BUILDING COMPLETION REPORT.

I beg to report that the building work on plot No. 76477 Sheet O.T. 6.
Old Town Quarter owned by Mr. Jethanand Heranand
has been completed according to plans approved by the Municipality. Orders
are requested to file the correspondence.

AMENDED
PLAN OF KITCHEN W.C. & BATH ON
PLOT NO. 76 & 77 SHEET NO. 6
OLD TOWN QUARTER
SCALE 8" = 1" INCH.

PROPOSED BUILDING TO BE BUILT ON PLOTS NO. 76 & 77.

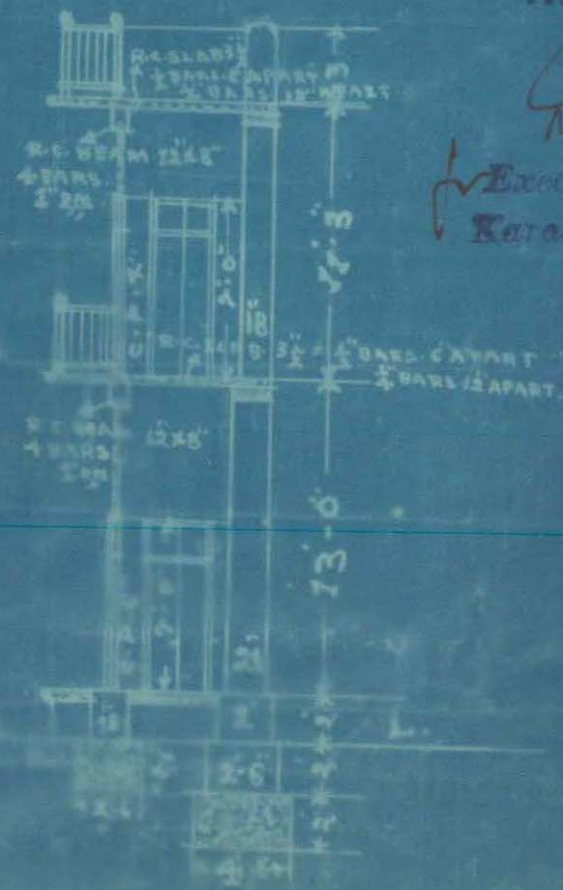
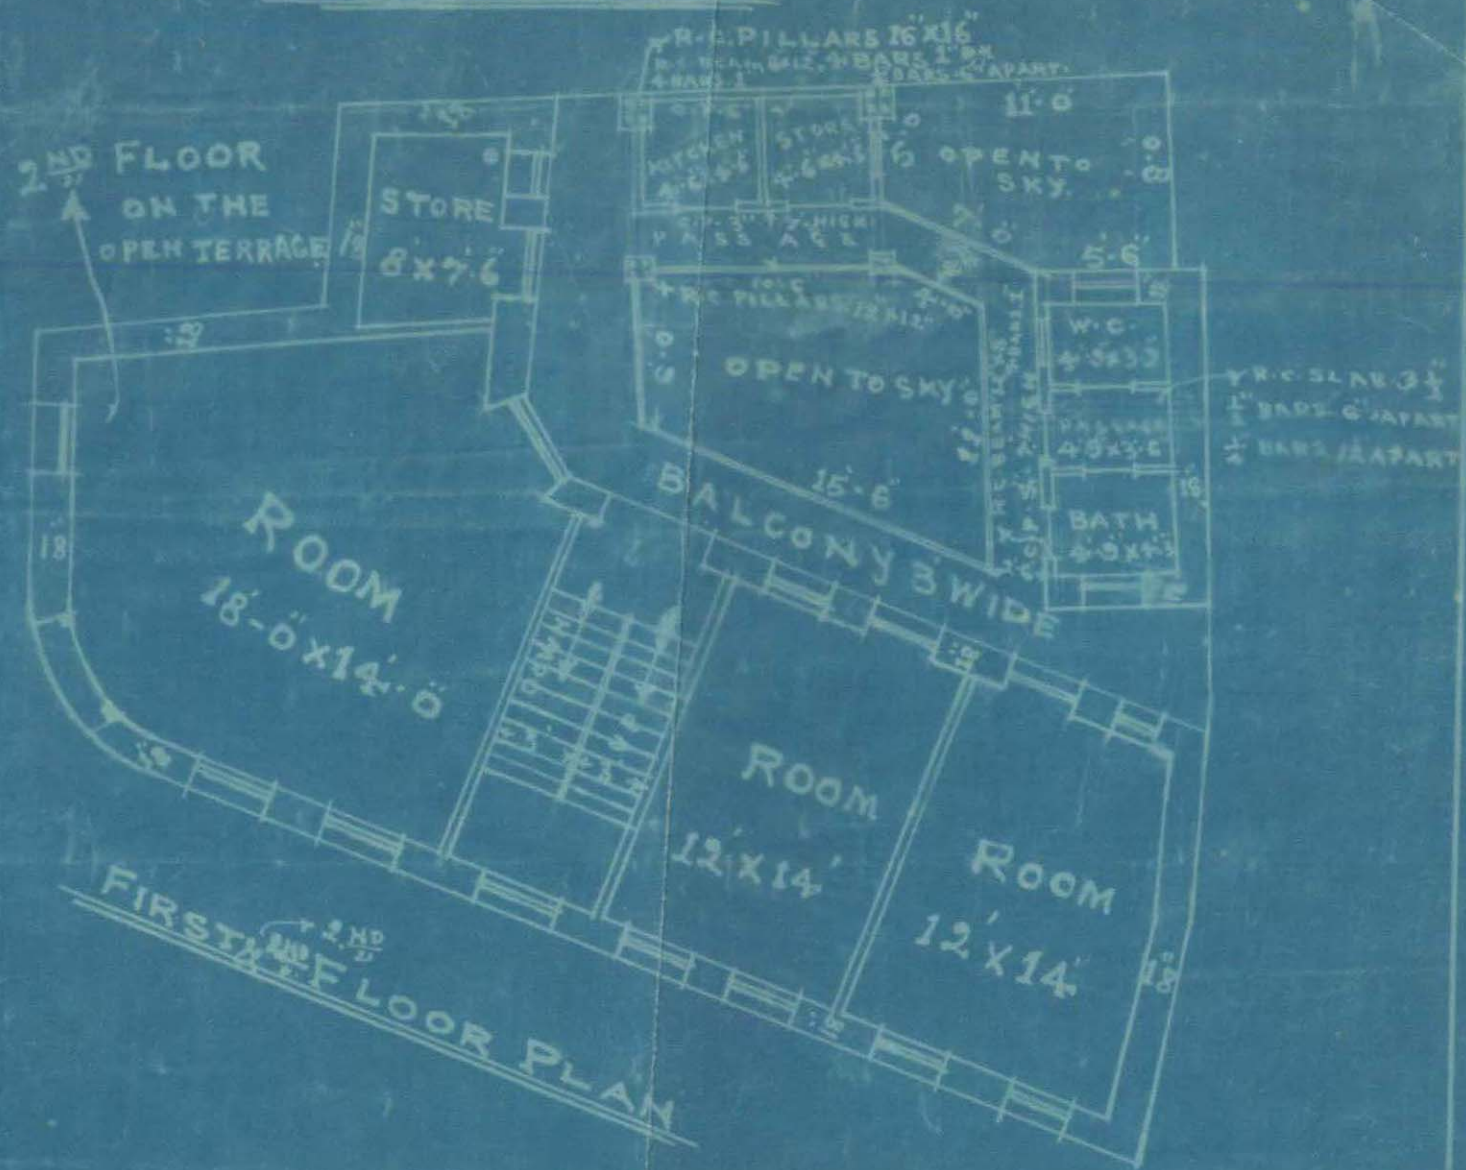
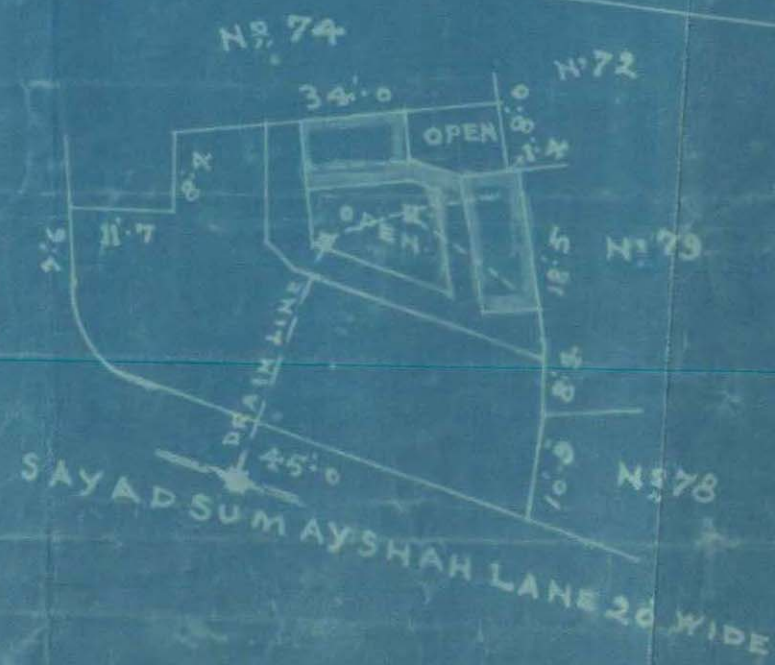
The architect has
Submitted plans showing
the whole building on one
Sheet, to which there seems
no objection. The plans may
therefore be passed.

AMENDED
PLAN OF KITCHEN W.C. & BATH ON
PLOT NO. 76 & 77 SHEET NO. 6
OLD TOWN QUARTER
SCALE 8" = 1" INCH.

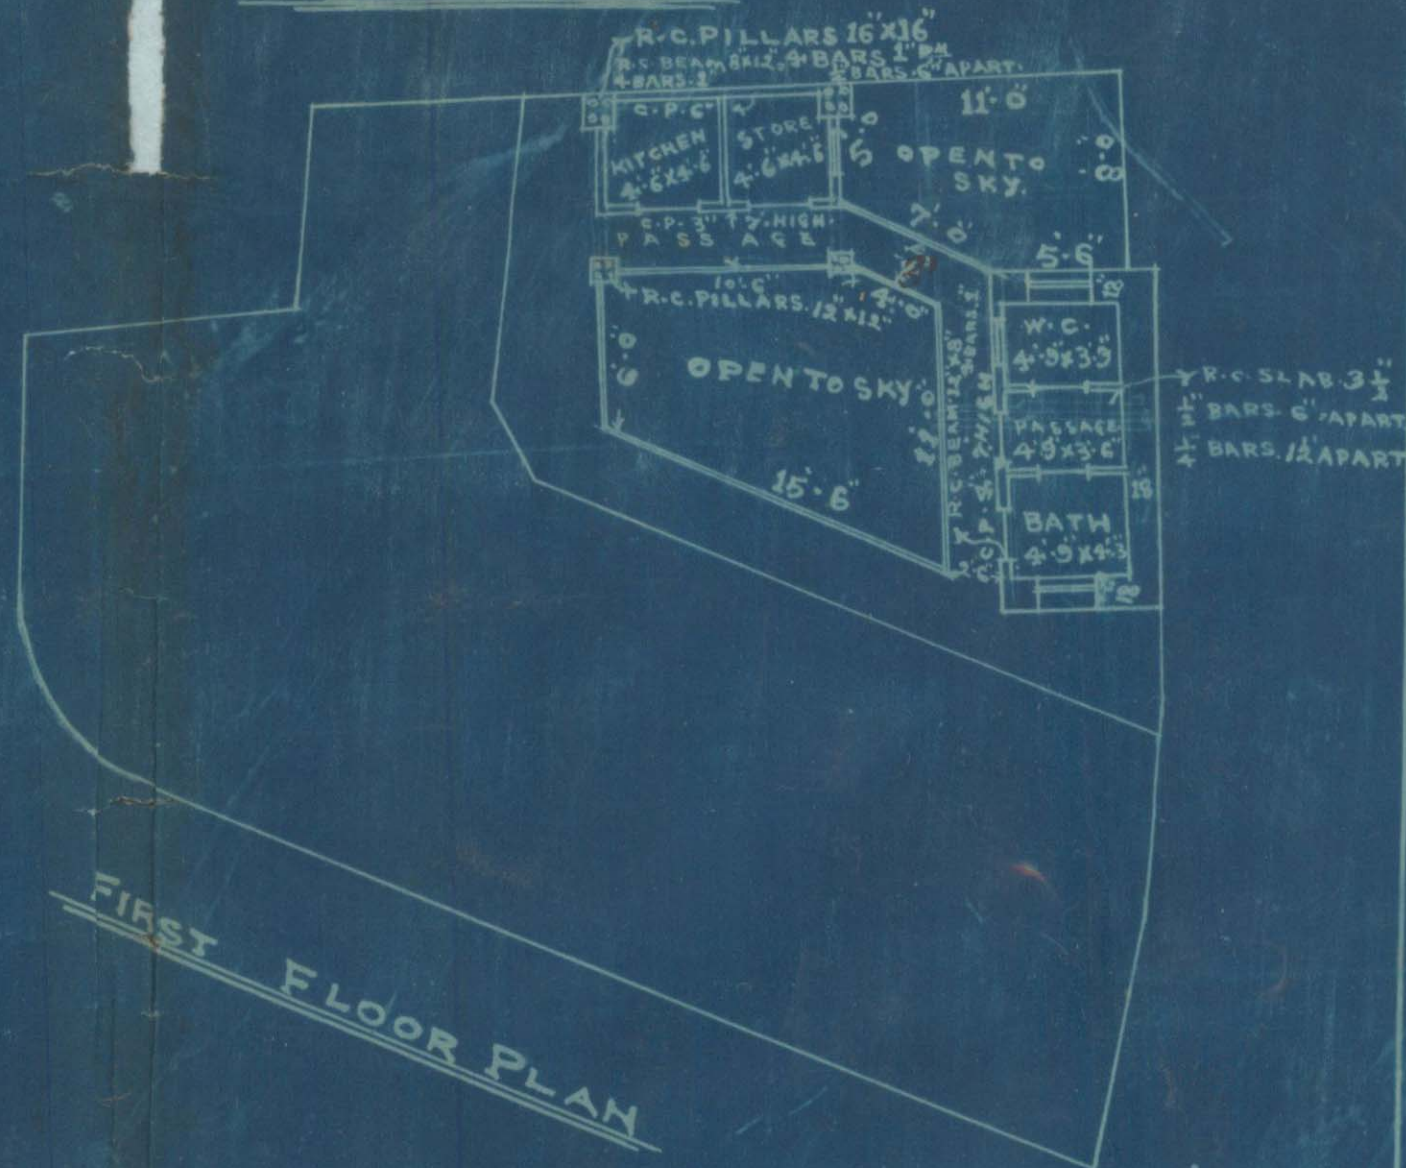
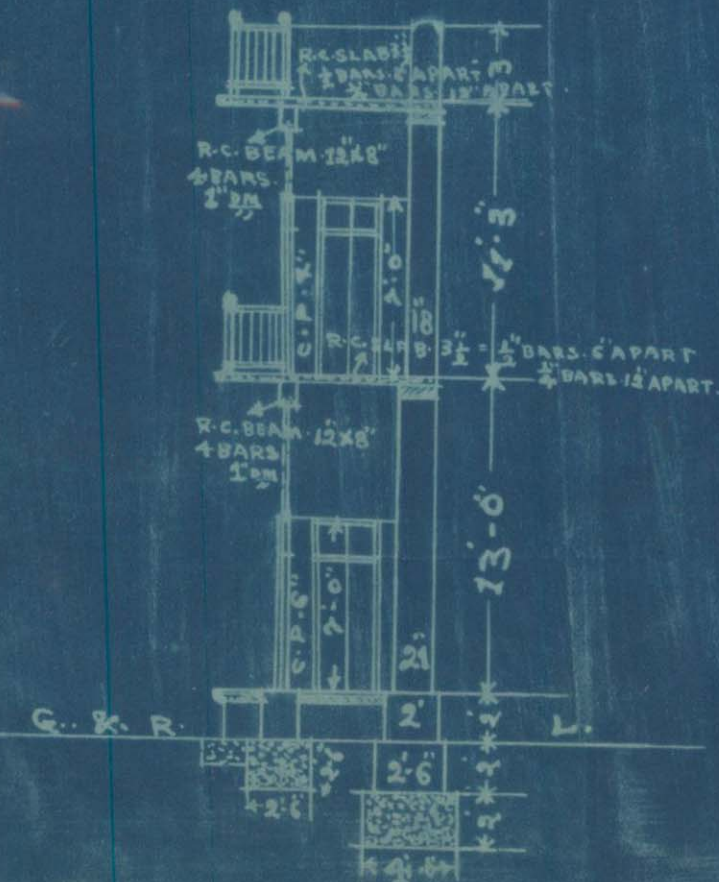
- (1) Complete plan is required to show the whole building on one sheet.
- (2)
- (3)
- (4)
- (5)
- (6)
- (7)
- (8)
- (9)

*Complete plan is required to show the
whole land on one sheet**Le*
*21/4/28**Plans may be attached.**10/5/28*

In compliance with your
memos no 47 & 48, dated 23/4/28
I have complied with your
requirements as complete plan
of whole building is given.

PLAN OF PROPOSED R.C. FLOORING ON
PLOT N^o 76 & 77 SHEET N^o 6
OLD TOWN QUARTER

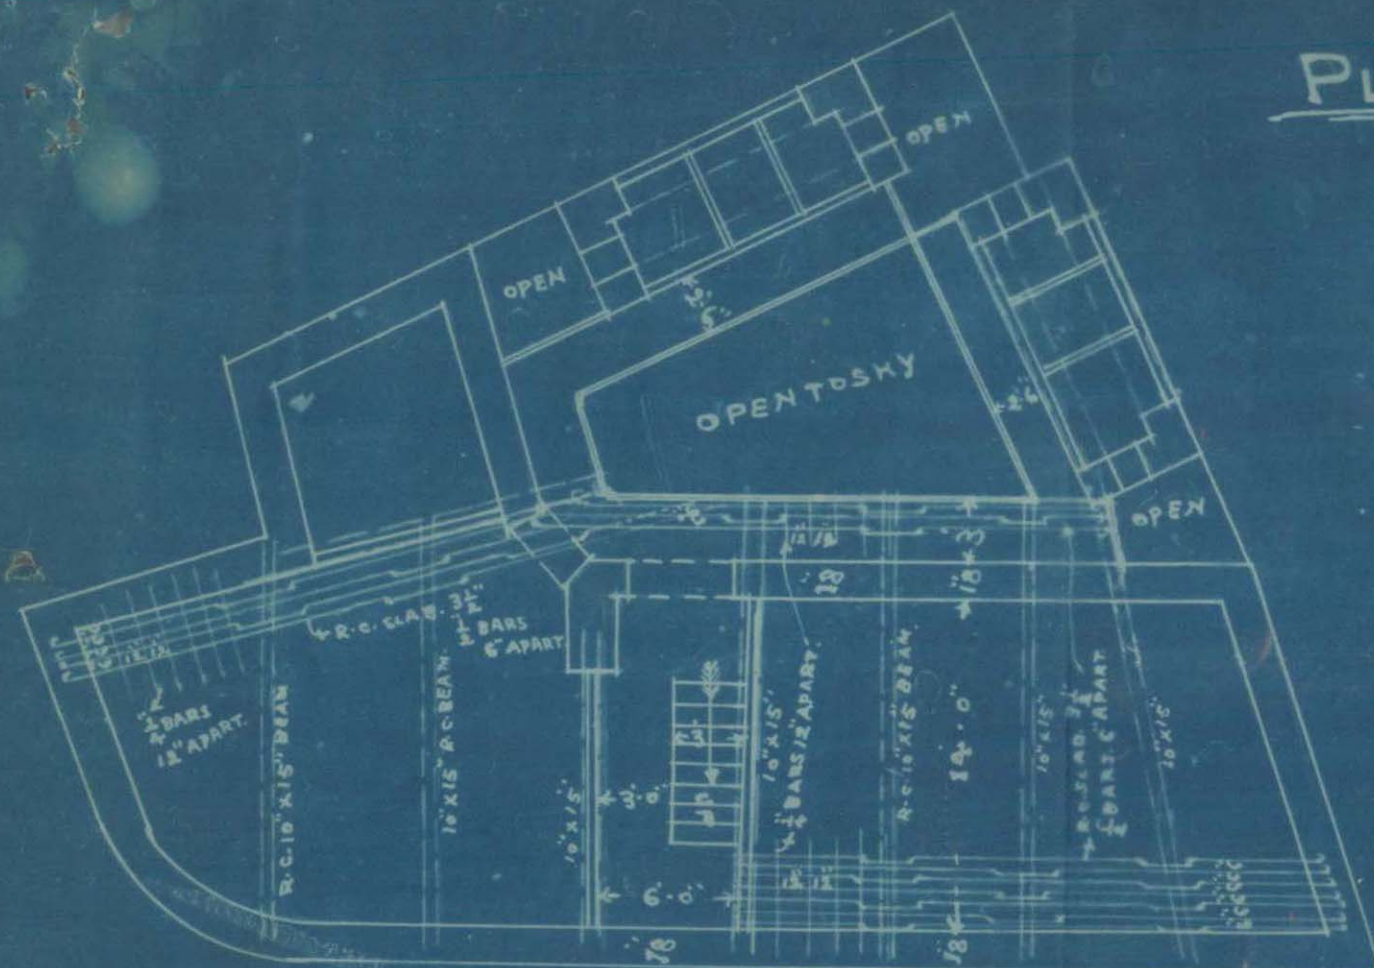
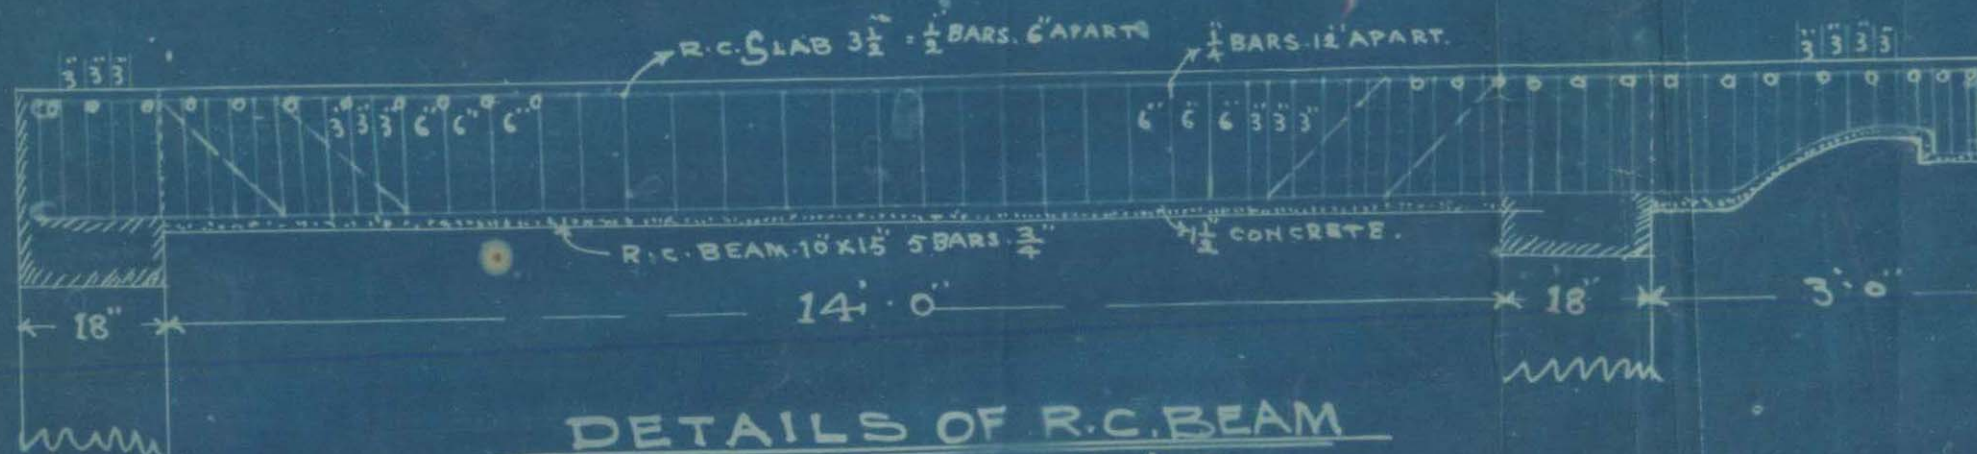
Reinforcement provided is more
than sufficient. There is no objection
to passing the plans.
